Access Compliance Report

Public Rights-of-Way

(Curb Ramps)

Intersection ID: N/A	Main Street: TUCKASEEGEE_RD	Cross Street: N/A	Location: W
ADA ID: A605251DC0A8	Ramp Type: Perp	Initial Pass/Fail: Fail	Overall Compliance: No
		Severity Score: 35

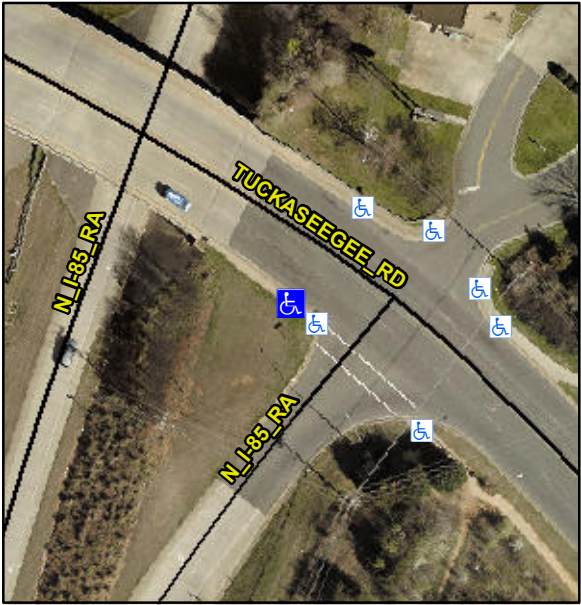
Codes/Mitigation Info/Possible Solution			Field Measurements/Component Compliance		
	Possible Solutions:		Compliance	Description	Data
	Remove & Replace Entire Ramp.		N/A	Ramp Length (in)	54.0
			No	Ramp Width (in)	41.0
			N/A	Flare Type LT	N/A
			N/A	Flare Slope LT (%)	N/A
			N/A	Flare Traversable LT?	No
			N/A	Landing Length (in)	N/A
			N/A	Landing Width (in)	N/A
			N/A	Landing Slope (%)	N/A
			N/A	Landing X Slope (%)	N/A
<p>Surveyor Notes:</p> <p>N/A</p> <p>PROW/ADA:</p> <p>Not Found, R304.5.1, R304.2.2</p>			N/A	Flare Type RT	N/A
			N/A	Flare Slope RT (%)	N/A
			N/A	Flare Traversable RT?	No
			N/A	DWS Provided?	N/A
			N/A	DWS Contrast?	N/A
			N/A	DWS Length (in)	N/A
			N/A	DWS Full Width?	N/A
			N/A	DWS Offset (in)	N/A
			N/A	Gutter Ponding?	N/A
			N/A	Gutter Lip Ht (in)	N/A
			N/A	Painted X Walk1?	No
				X Walk 1 Direction	To NE
			N/A	X Walk 1 Width (in)	N/A
				X Walk 1 Slope (%)	3.9
				X Walk 1 X Slope (%)	2.7

N/A	Ramp inside XWalk1?	N/A
				Road Slope (%)	N/A
				Road X Slope (%)	N/A
			N/A	Any Obstructions?	N/A
				Obstruction Type	
Total Cost: \$ 1850.00			N/A	Storm Grate/Utility Hazard?	N/A
				Storm Grate/Utility Type	
			N/A		N/A
			Yes	Surface Condition? (G/P)	Good
